RE: AUGUST 2020 RFI RESPONSE

Block 4B Central Park Adaptive Reuse (SSD-9374) + S75W Central Park Concept Plan Modification 16 (MP06_0171)

Figure 2 Tripartite Structure to North facade comparison

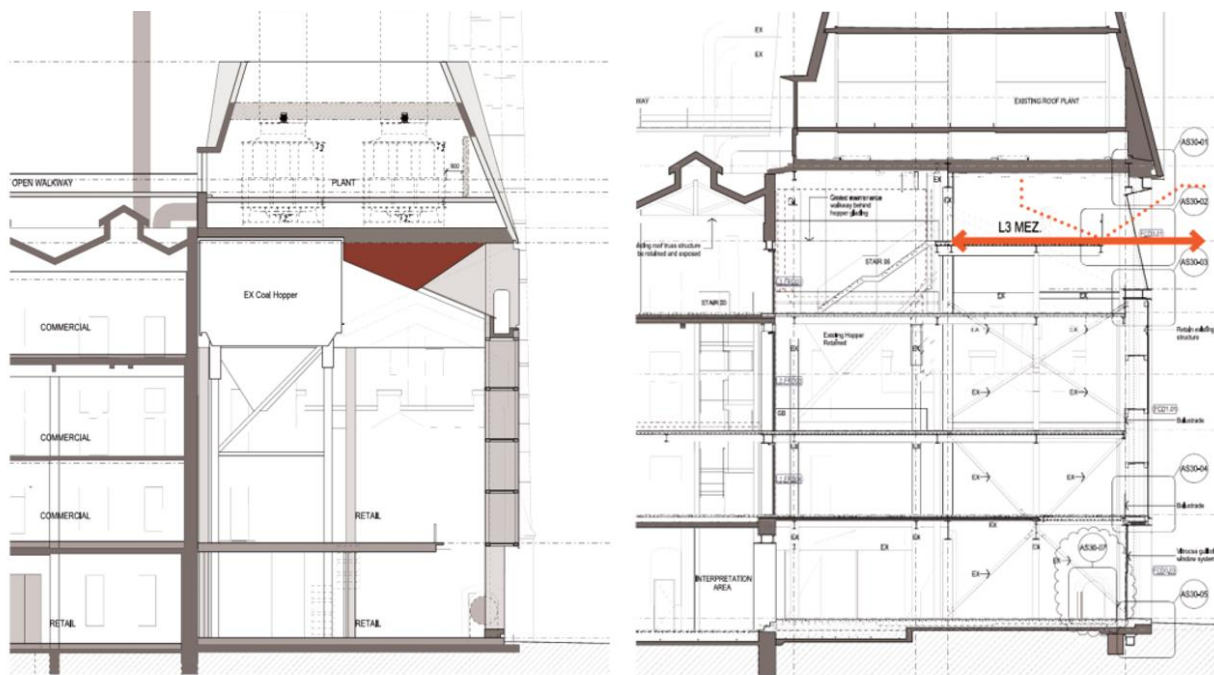
CoS maintain in their letter dated 24 August that the ‘bird mouth recess’ design is an important interpretation of the original structure and have further clarified that they believe has the scope to show the hoppers from the public domain. **Figure 1** below shows comparison between the “birds mouth recess” design from MP10_0217 which was approved in 2012 and the current proposal.

Figure 2 above demonstrates that the tripartite design of the façade, which was a key component of the original design intent, has been maintained. These lines relate to the open ground plane and the parapet line of the existing adjacent brickwork. The new façade design aligns to the parapet line of the existing adjacent brickwork and then changes geometry above the parapet to slope at right angles to the soffit at the upper level of the hoppers within the northern roof.

Figure 3 Building 30 ceiling profile comparison

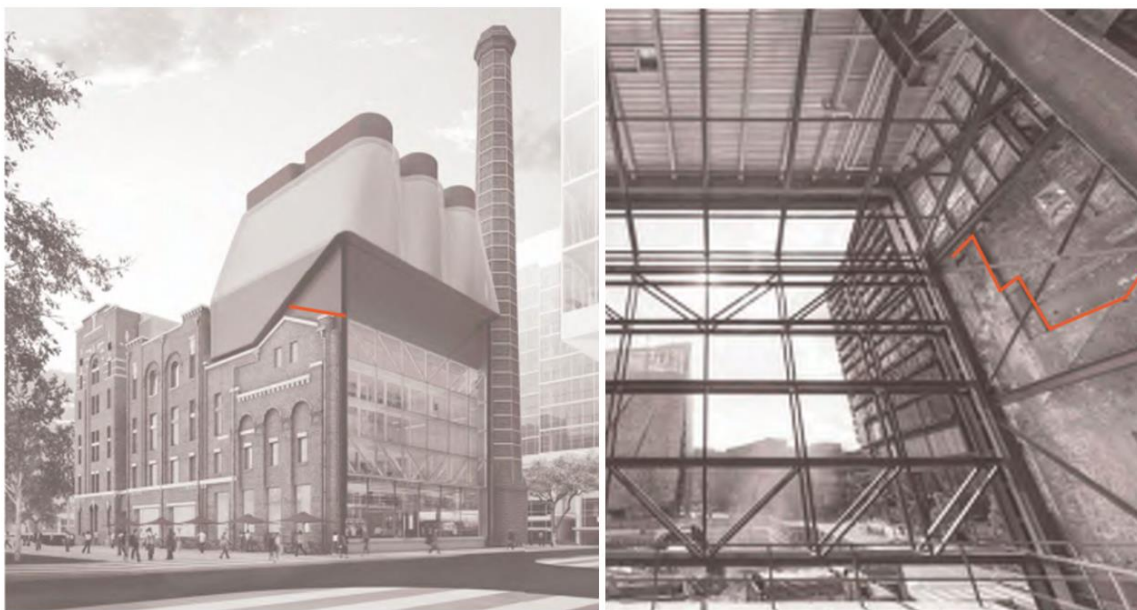
MP10_0217 Section
 Ceiling profile no longer required for Tri-Gen services and blocks relationship of the top of the hopper with the broader space of the northern room

Proposed SSDA Section
 Ceiling profile and upper level glazing amended to open up relationship of the top of the hopper with the broader space of the northern room

The alignment of the angled skylight and the approximate line of the existing gable was not a determining factor of the original design. The skylight, although it had a similar angle, has a different height and was determined by the potential need for services reticulation under the Tri-generation plant (refer to **Figure 4**). When these services were better understood and no longer required an opportunity was recognised to fully integrate the whole of the hopper into the northern room. The previous soffit design allowed views to parts of the hopper but retained the hopper in its own space.

Figure 5 Original SSD-9374 Building 30 View of Hoppers

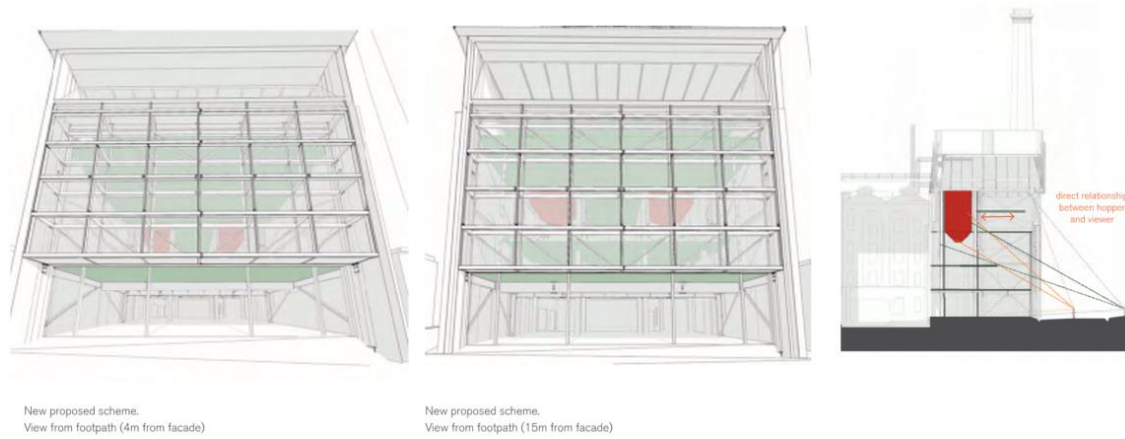
Opportunities to improve views of the remaining two coal hoppers from the public domain, noting that Council does not support the proposed mesh interpretation of the proposed removed coal hopper.

Figure 5 depicts the applicant’s original proposal, showing the impact on views of the hoppers from the public domain. As requested by CoS a design alternative developed during the consultation with the CoS is shown in **Figure 6** which maintains the interpretive potential of close contact with the retained hoppers in different floor levels, with better visual connection from the public domain through the redistribution and reduction of floors in this space.
